DOE RESPONSES TO WVDP PHASE 1 DECOMMISSIONING PLAN RAIS

**Figure 6-1. Unit Remediation Costs vs. Monetary Discount Rate**

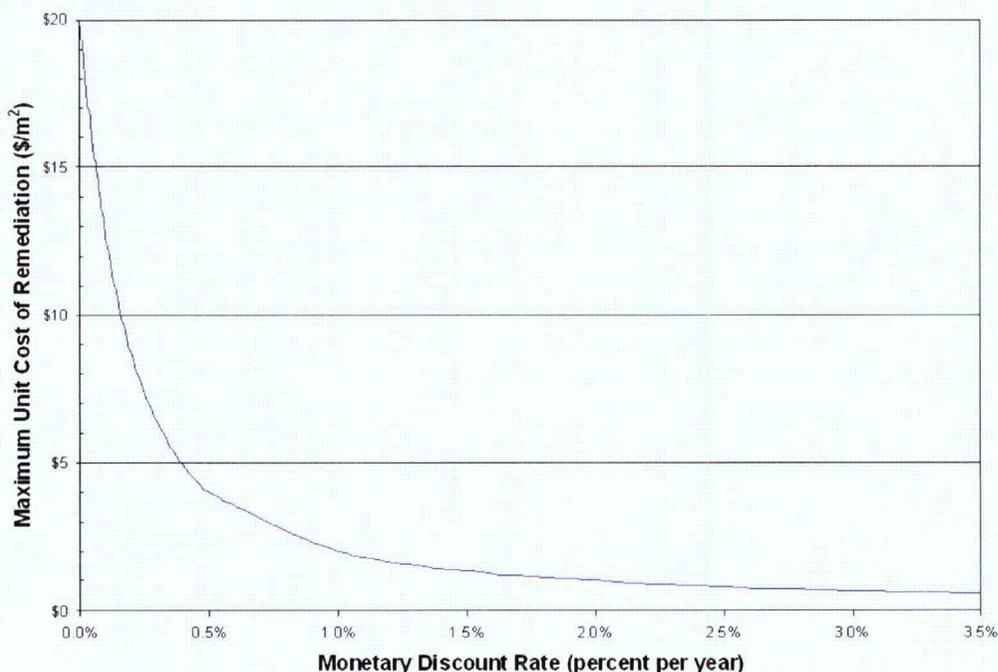
**RAI:** Calculations of costs and benefits for ALARA analyses: Provide either an evaluation using zero discount rate or a sensitivity analysis of the discount rate for the present worth calculations for the value of future dose averted. (Section 6.3, Page 6-5):

**DOE Response:** A new Subsection 6.3.6 will be added to address intergenerational concerns, with the results of a preliminary ALARA analysis using no discounting. Information will be added to Section 6.4 also to address intergenerational concerns.

Figure 6-1 shows the unit cost of remediation ( $C_{TU}$ ) as a function of the discount rate. It shows that with a discount rate of zero, the cost of remediation would be approximately \$20/m<sup>2</sup>. Because this unit cost is less than the \$36.38/m<sup>2</sup> disposal component of the total remediation cost in the preliminary analysis (Section 6.3.3), the DCGLs result in intergenerational doses that are ALARA and further remediation would not be necessary.

**Figure DC1-1. Sheet Piling Supporting the Fuel Storage Pool Excavation Looking to the West**

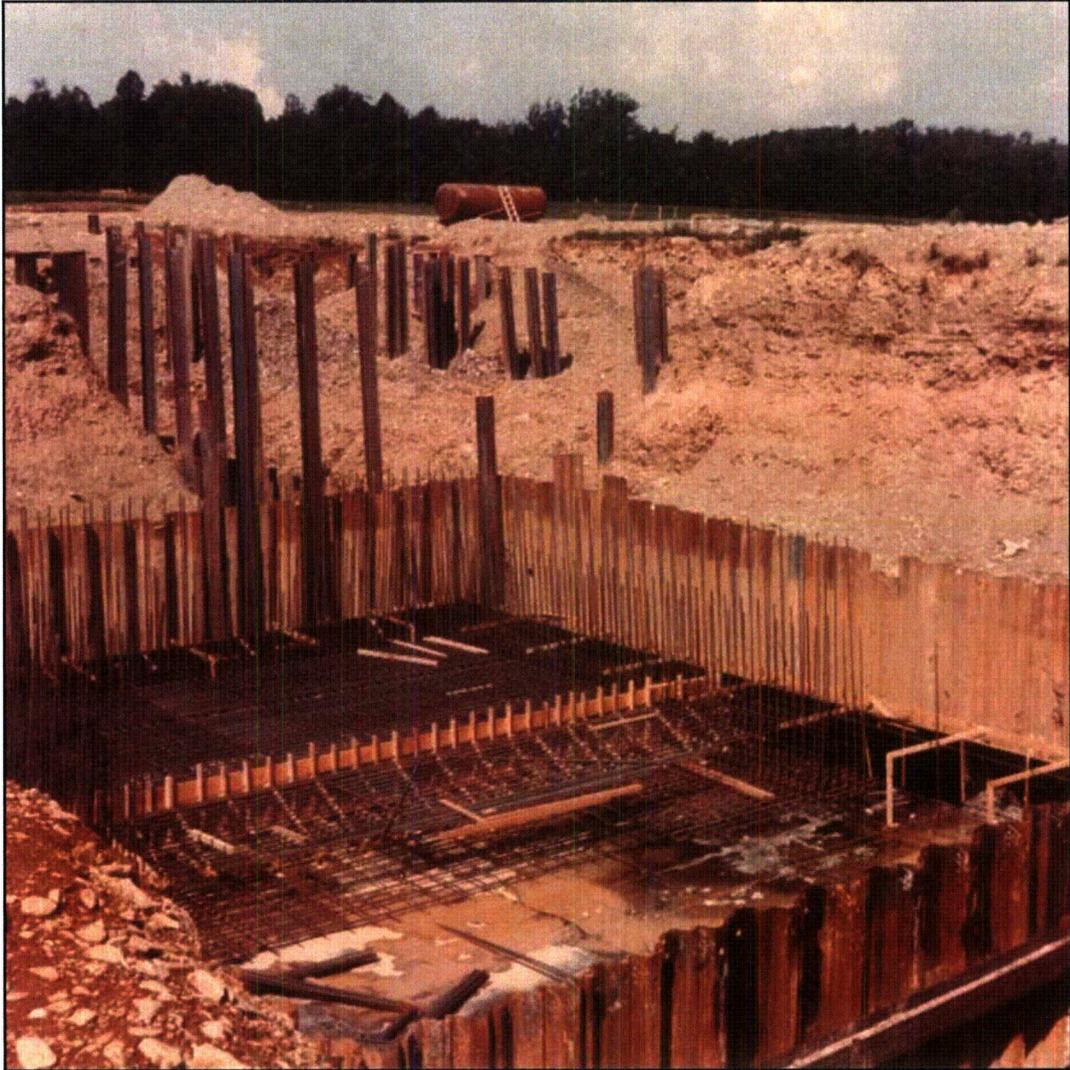
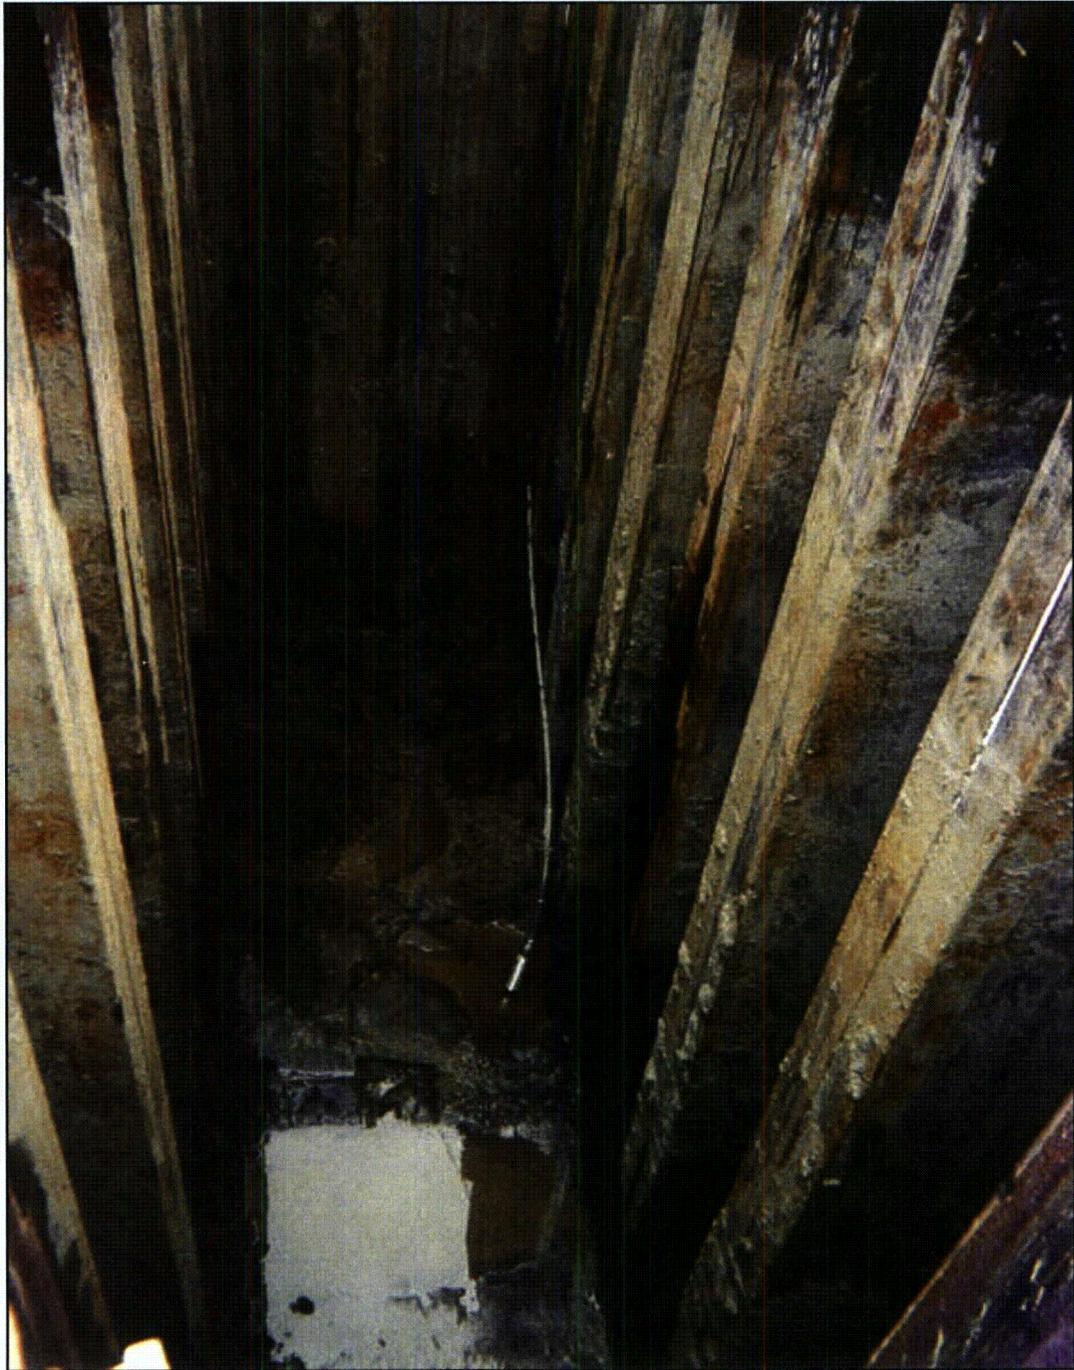
**RAI:** Section 7.4.3 states that before soil excavation takes place groundwater extraction wells will be installed and placed in operation to dewater the excavation. Details of the dewatering design were not provided in the DP. It is also not clear in Section 7.4.3 how the planned hydraulic barriers will prevent infiltration of upgradient groundwater into the WMA 2 excavation or how excess water will be managed. (Section 7.3.8, Page 7-25; Section 7.4.3, Page 7-32)

**Basis:** The total depth of the planned excavation for WMA 1 is approximately 13.5 m (45 ft), with more than half of the excavation below the water table. Groundwater will continue entering the excavation from below the sheet pile in the upgradient direction. Information on the amount of water to be pumped will help determine the number of wells and need of potential water treatment equipment/facility.

DOE expects that groundwater in the two large excavations can be effectively managed using conventional methods. Photographs taken during excavation and construction of subgrade cells in the Process Building and the waste tank farm excavation, some of which did not use sheet piling, suggest that this will be the case. See Figure 7C1-1. Also see Figures DC1-1 and DC1-2 with the response to RAI DC1.

Interlocking sheet piling was used during the construction of the Nuclear Fuel Services (NFS) fuel reprocessing facility in the early 1960's and by the WVDP during the installation of the pilot-scale permeable treatment wall in 1999. Photographs taken during the construction of the NFS Fuel Receiving and Storage show that interlocking sheet piling was used to support the excavation and construction of the Fuel Receiving and Storage Fuel Storage Pool (Figure DC1-1) and Cask Unloading Pool (Figure DC1-2). The sheet piling was used to support the excavation of the sand and gravel unit to a depth of 30 feet for the Fuel Storage Pool, and to a depth of 50 feet for the Cask Unloading Pool which extends into the Lavery till, an impermeable clay-rich glacial till which underlies the sand and gravel unit. The lack of water in the bottom of the Fuel Receiving and Storage excavations suggests the sheet piling was effective in preventing groundwater infiltration into the excavations.

A photograph showing the driving of foundation piles in the General Purpose Cell excavation (Figure DC1-8) does not indicate that sheet piling was used to support this excavation which was approximately 35 feet deep. Infiltration of groundwater does not appear to have been a problem as the bottom of the excavation surrounding the pile driving crane appears dry.
